AR7030 technical bulletin 004

Audio Output Instability

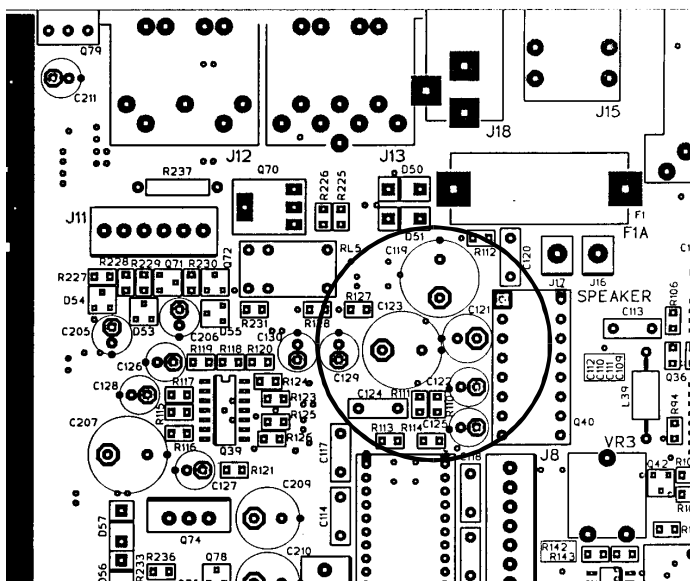
C122. The components are located near the fuse in the left hand corner of the set as shown in the PCB layout alongside.

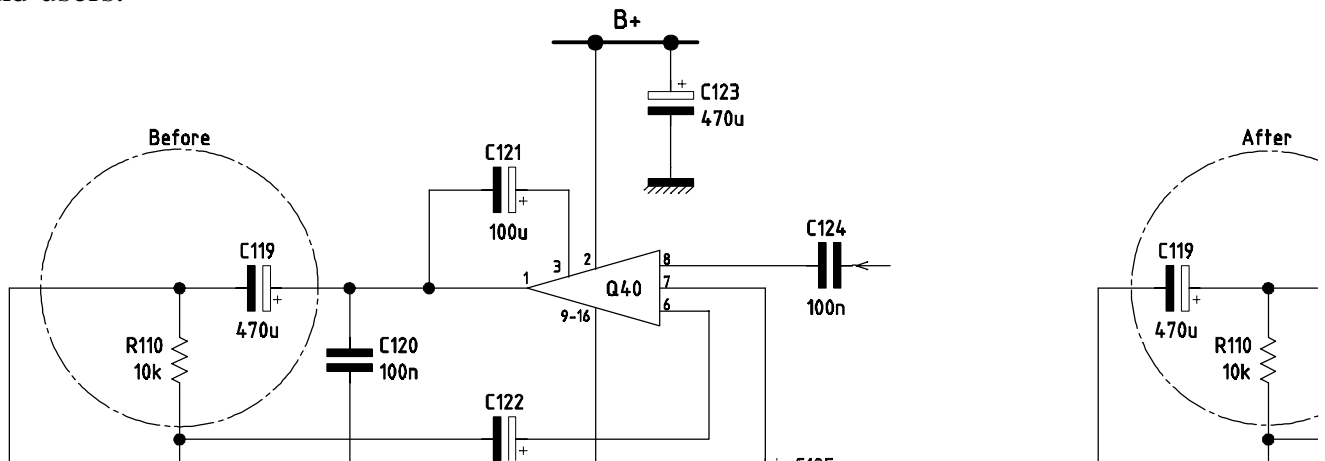
It has been found that when using certain high quality external "Hi Fi" speakers there is a possibility that the audio stage may become unstable and oscillate at a very low frequency, typically < 10Hz.

The modification involves the repositioning of C119 and R110 in the audio amplifier output feed as shown in the diagrams above.

In practice the modification is carried out simply by removing the SMD resistor R110 and repositioning it using a conventional component on the underside of the board. Connect the new resistor between the +ve leg of C119 and the -ve leg of
